## DRIVE UPDATE 512 SNOWTHROWER SPEED-UP KIT

Part Number 604315

To be used for 512 snowthrower with 11 tooth drive sprocket.

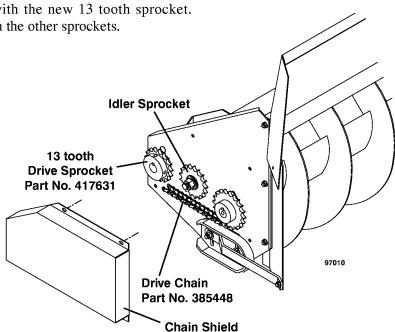
- 1. Remove the chain shield from the side of the auger housing.
- 2. Loosen the idler sprocket and remove the drive chain.
- 3. Remove the existing drive sprocket and replace it with the new 13 tooth sprocket. Align with the other sprockets.
- 4. Remove pins from chain so that it is 48 pins long.
- 5. Install drive chain on sprockets.
- 6. Tighten idler sprocket to the proper chain tension.
- 7. Install chain shield.
